**CERTIFICATE OF APPROPRIATENESS****Application Date:** June 25, 2014**Applicant:** Stephen Heiman, Stephen Allen Design, for Robert Garner, owner**Property:** 521 Euclid Street, Lot 1, Tracts 11 and 12A, Block 22, Woodland Heights Subdivision. The property includes a historic 1,222 square foot one-story wood frame single-family residence and a detached garage situated on a 5,000 square foot (50' x 100') interior lot.**Significance:** Contributing Craftsman style residence, constructed circa 1920, located in the Woodland Heights Historic District.**Proposal:** Alteration – Construct a two story 2,049 square foot addition on the rear and on top of a one story 1,222 square foot contributing residence. When factoring the removal of a non-original rear addition, this results in a net square footage of 2,876 for the proposed altered residence.

Application is a resubmittal of an item that was deferred on July 17, 2014 in order to allow the applicant time to correct elements of their design that staff found to not meet the approval criteria.

**Public Comment:** No public comment received.**Civic Association:** No comment received.**Recommendation:** Denial – Does not meet criteria.**HAH

**3D RENDERING – FRONT FACING EUCLID**

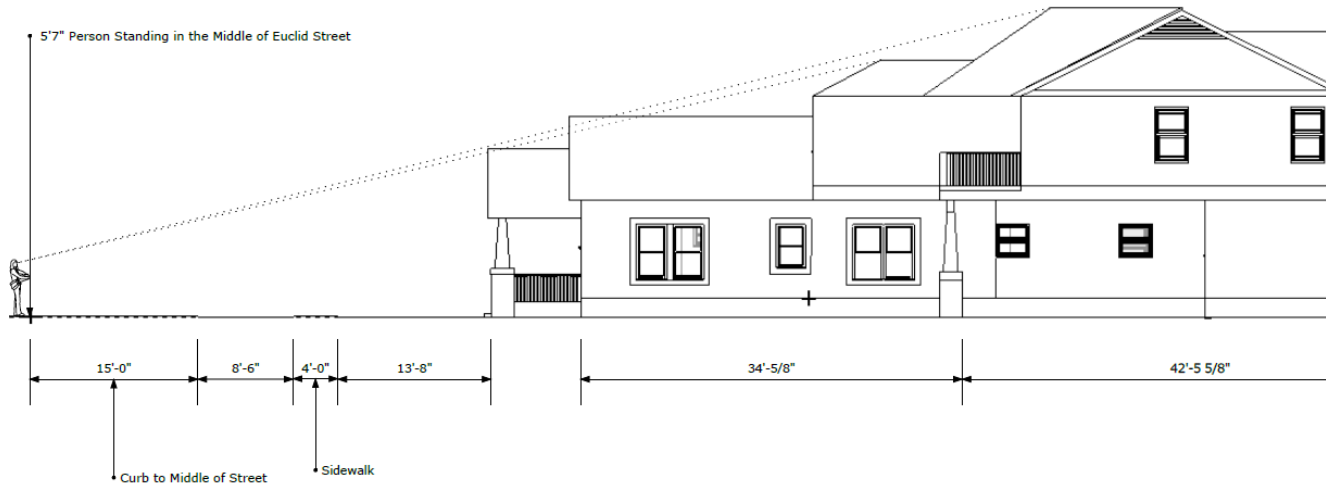
Although the simplification of visual elements and moving the addition behind the existing original house are appropriate changes, the increased height and movement of the upstairs living space closer to the street present additional compatibility issues with the scale of the addition.

**SOUTH ELEVATION – FRONT FACING EUCLID STREET**

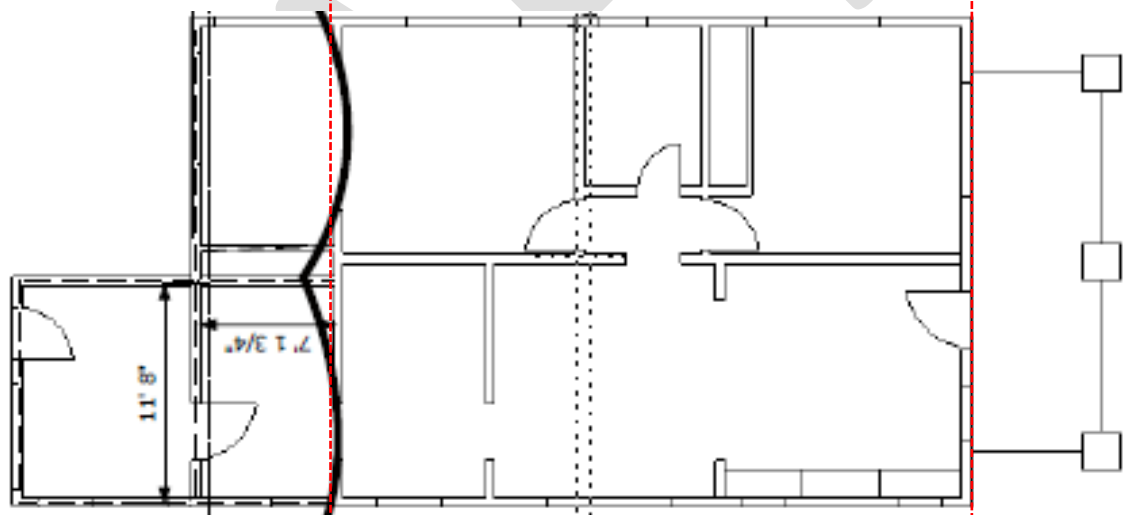
*Side hipped and side gable roof changed to side gable*

**EAST SIDE ELEVATION**

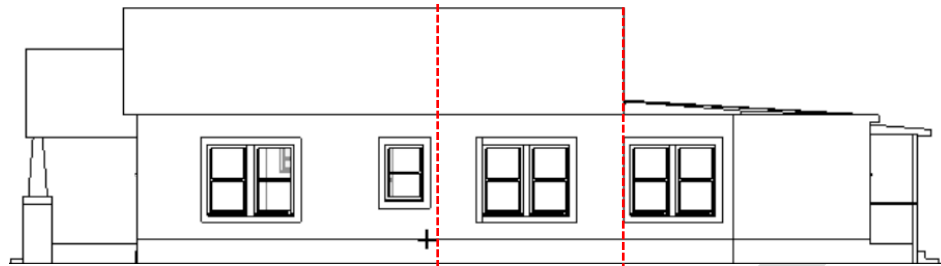
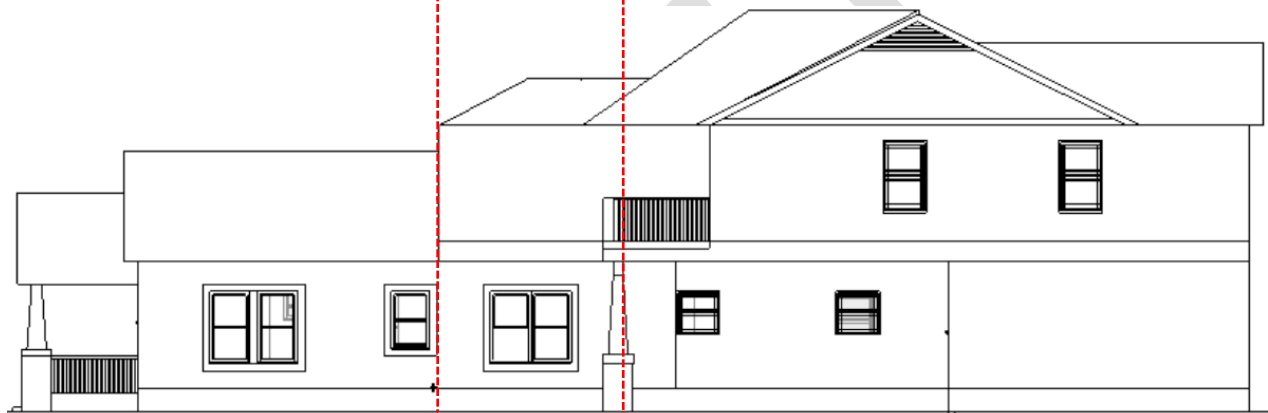
Revised: Hipped roof changed to side gable

Revised: addition no longer encroaches on the existing structure
